Application by  
Fingal County Council  
for Waste Licence Application W0231-01  
for Fingal Landfill, Co. Dublin

***Replies to Request  
for further information in accordance with  
Article 14(2)(b)(ii) of the Waste  
Management Regulations***

May 2007

**APPENDIX 1**  
**GROUNDWATER LEVELS**

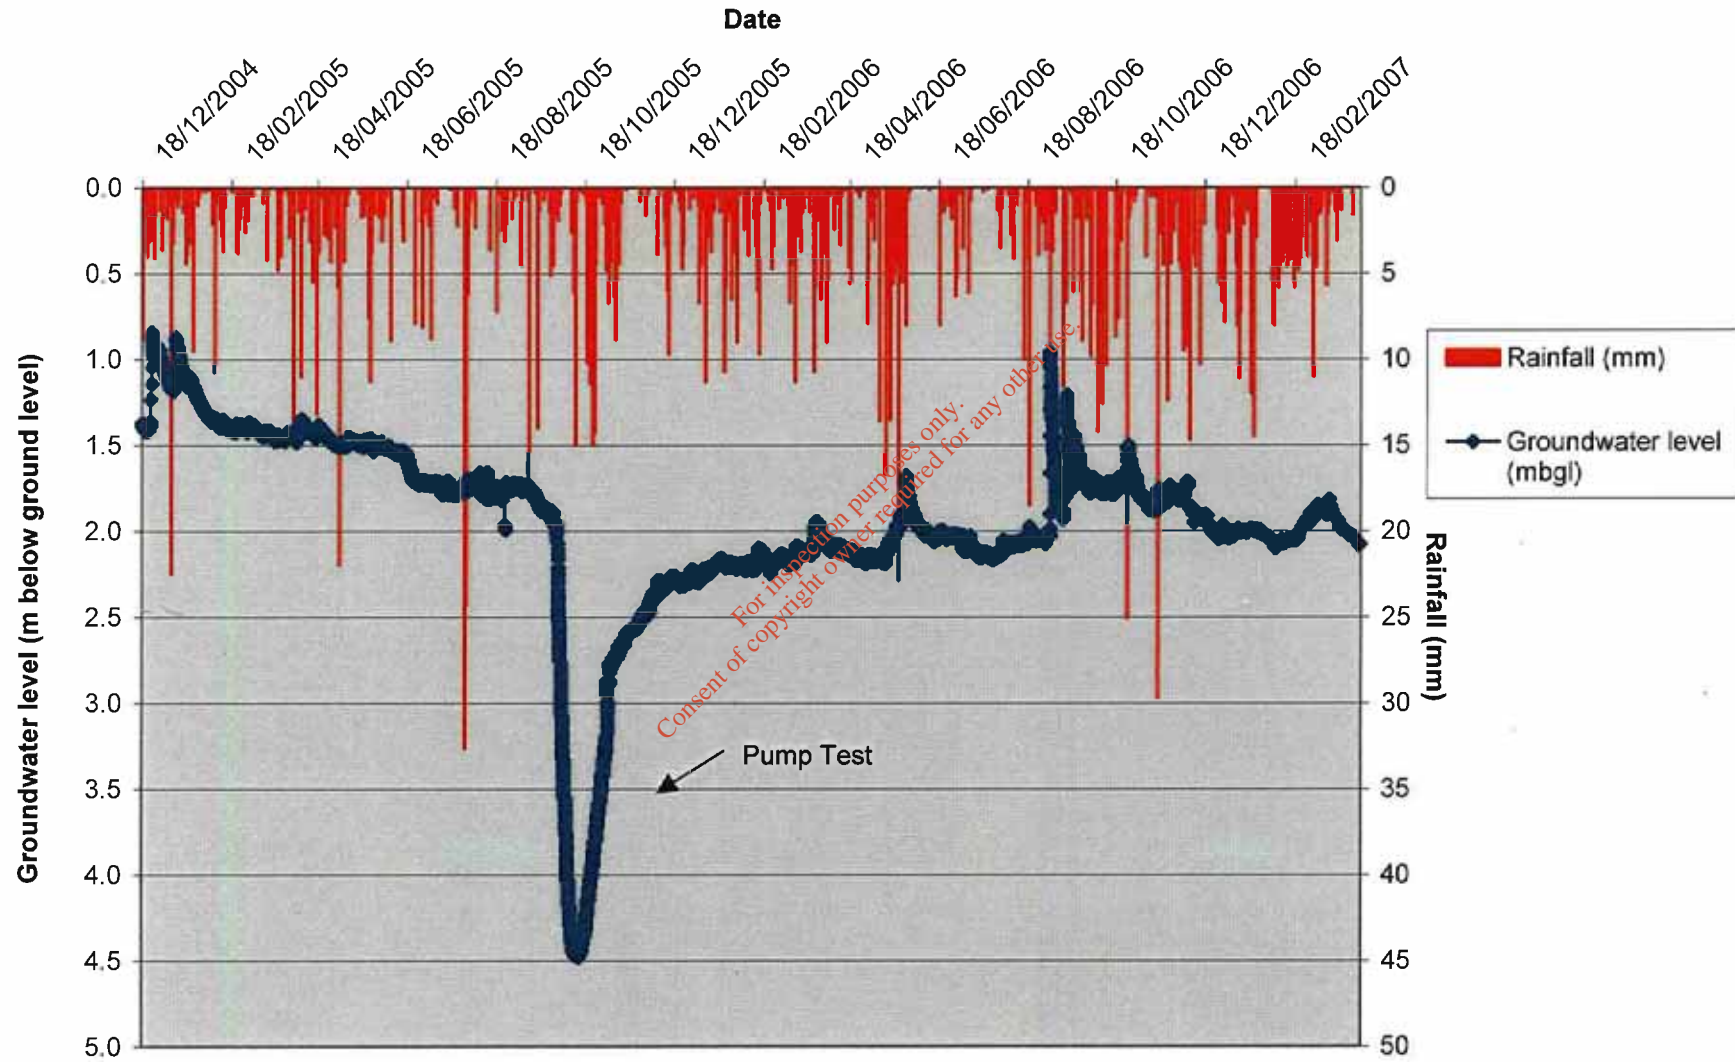
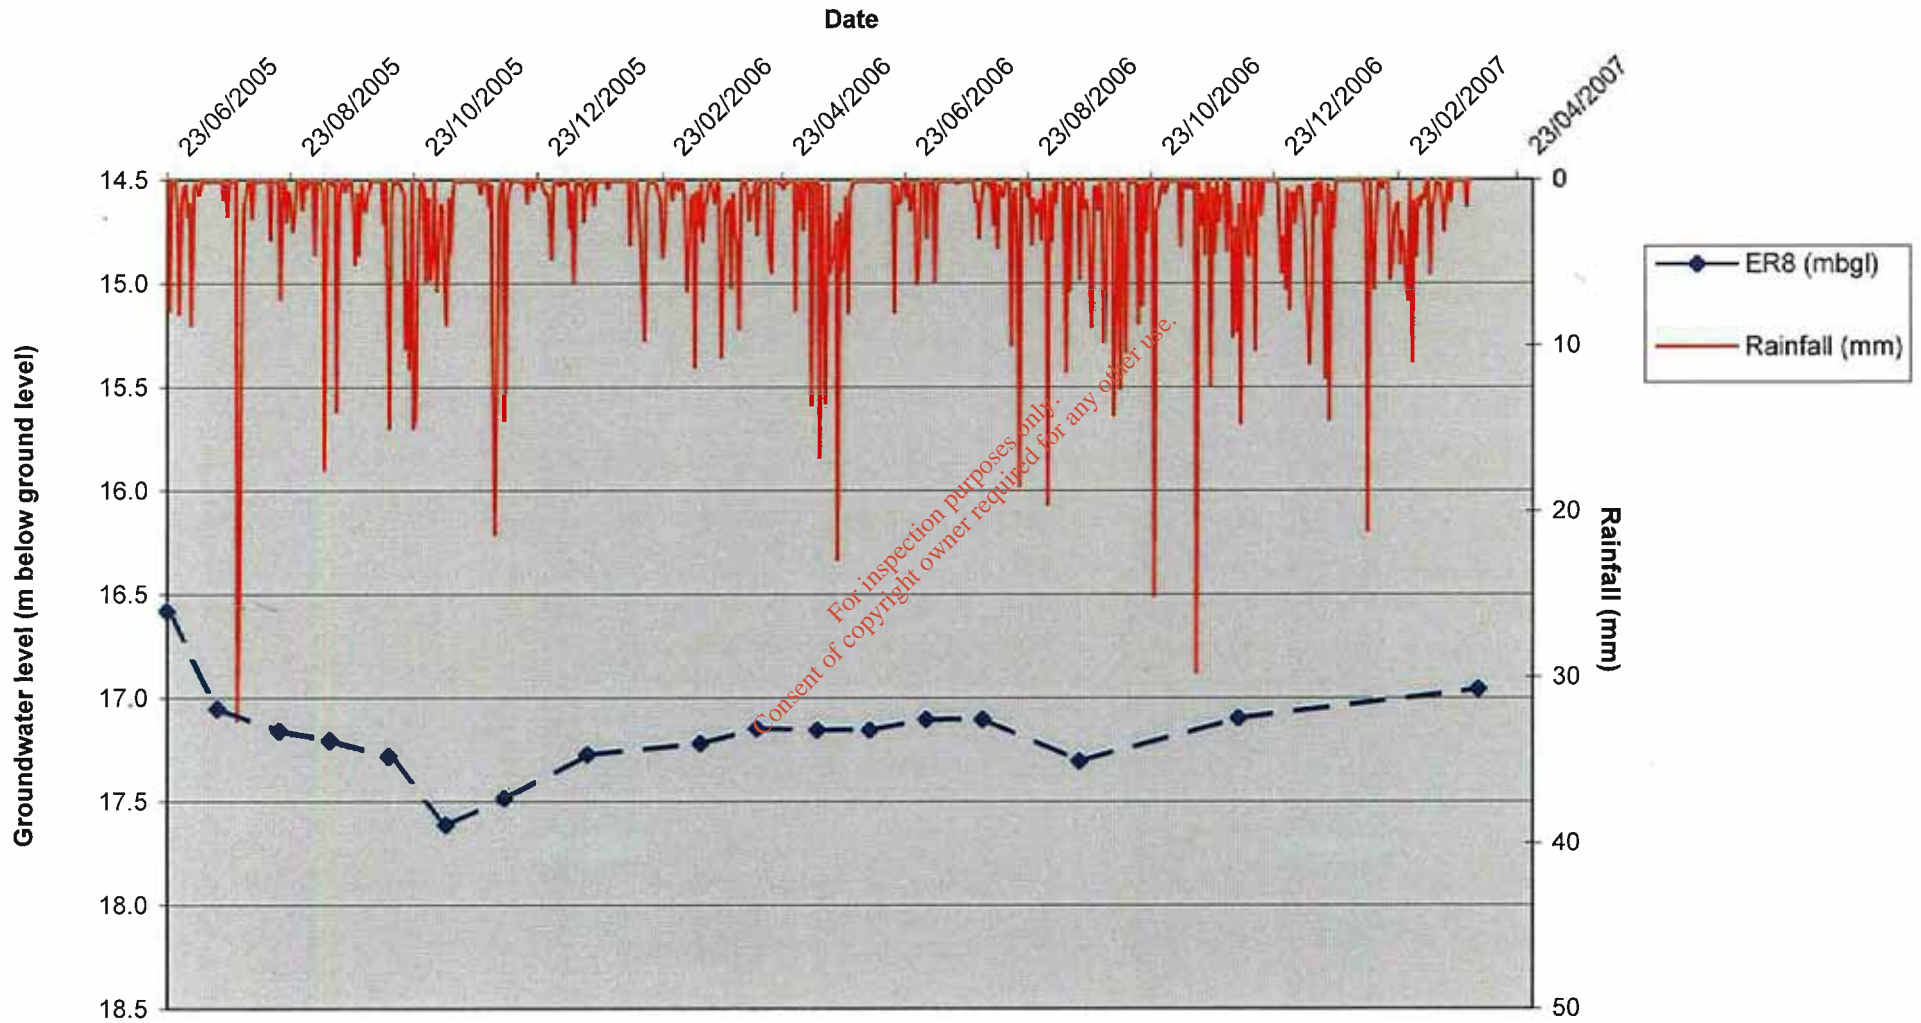
***Video recordings accompanying Submission No. 74 and No. 79 (DVD copies attached) indicates that the boreholes ER8, SHR3a and BSA1 are artesian. This is in disagreement with the monitoring data submitted with the application and with additional supplied information. Please comment on these findings and on the video recordings of boreholes submitted (copy attached).***

Measured water levels have been consistently below ground level in ER8, SHR3a and BSA1 and are included in **Appendix 1**. These demonstrate that the monitoring wells are not artesian.
